ENVIRONMENTAL PROTECTION AGENCY

Final Response to Petition From New Jersey Regarding SO₂ Emissions From the Portland Generating Station

ACTION: Final rule.

Figure VI.C-1. Comparison of 2010 Emissions from Portland Units 1 and 2 with Allowable Emissions and Different Levels of Reduction from Allowable Emissions.

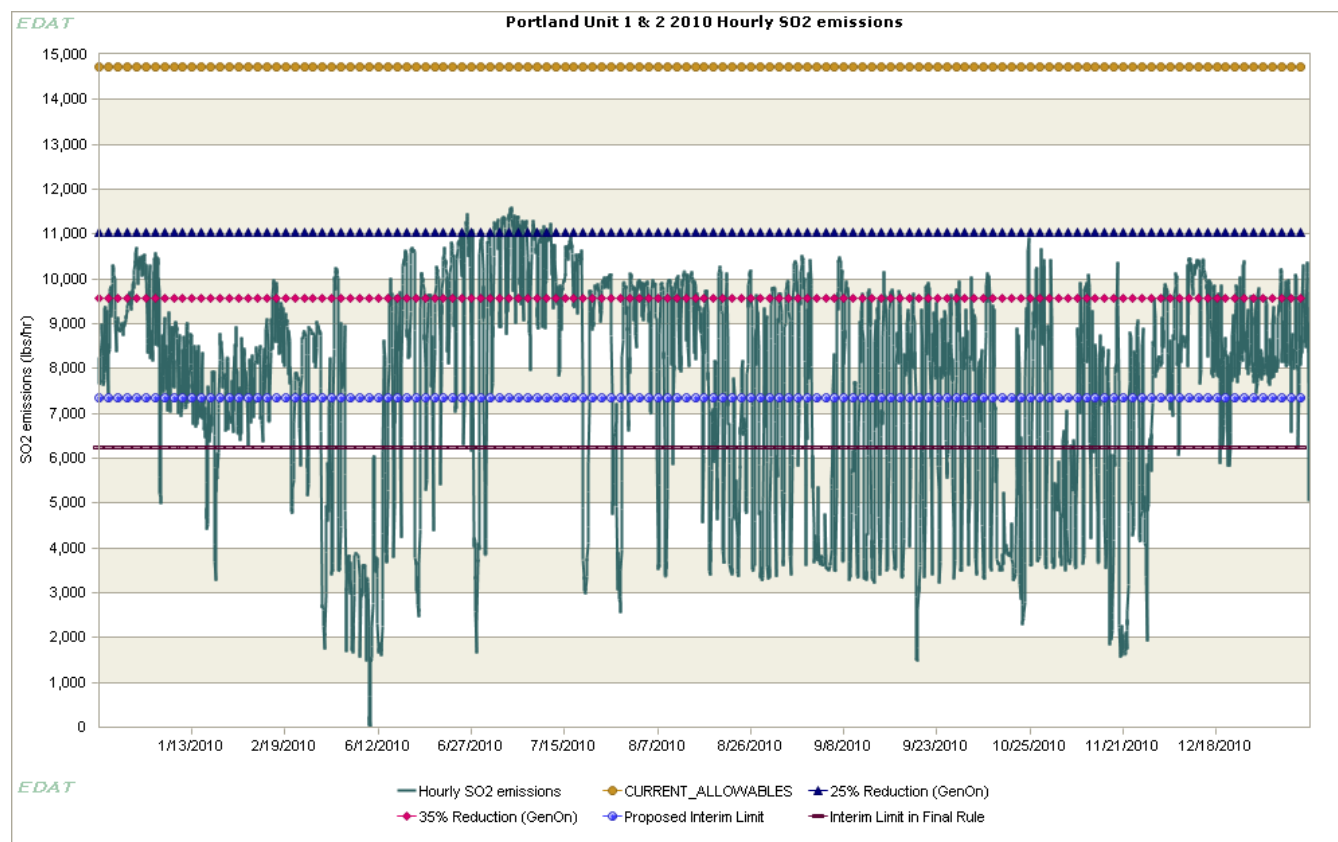
Comment: Based on the results of the test burn report, GenOn concluded that (1) sustained unit operations using a blend of Northern and Central Appalachia coals sufficient to achieve a 25 percent reduction in allowable SO₂ emissions is achievable with a modest investment and an implementation schedule of 6 months, and (2) sustained unit operations using a blend of Northern and Central Appalachia coals to achieve a 35 percent reduction in allowable SO₂ emissions should be achievable with additional investments and an implementation schedule of 8 to 12 months after GenOn has established an operational record and completed equipment performance evaluations at the 25 percent reduction blend level, and any necessary permits are acquired.

Response: The EPA evaluated the suggested interim reductions in the GenOn test burn report. The EPA concluded that based upon this evaluation, these targets are significant underestimates of the readily available interim emissions reductions, represent very minimal reductions from current operations, and are inconsistent with the results of the test burn.

Figure VI.C-1 shows the hourly SO₂ emissions for all of 2010 at Portland, shown as the sum of emissions from units 1 and 2. For the EPA (and GenOn's) air quality analysis, the assumed allowable emissions rates for units 1 and 2 were 5820 lb/hr and 8900 lb/hr, respectively, resulting in a total allowable rate of 14,720 lb/hour. A 25 percent reduction from this amount, that is a 25 percent reduction from current allowable, thus becomes 11,040 lb/hr. As shown in Figure VI.C-1, during 2010, Portland's hourly emissions exceeded 75 percent of allowable emissions only rarely. Accordingly, a 25 percent reduction in allowable emissions effectively represents status quo operations. A 35 percent reduction in allowable emissions, or 9,568 lb/hr, would require at most a roughly 15 percent reduction in current emissions. EPA continues to believe that the facility can make much more significant reductions in line with the final interim limits within a year.
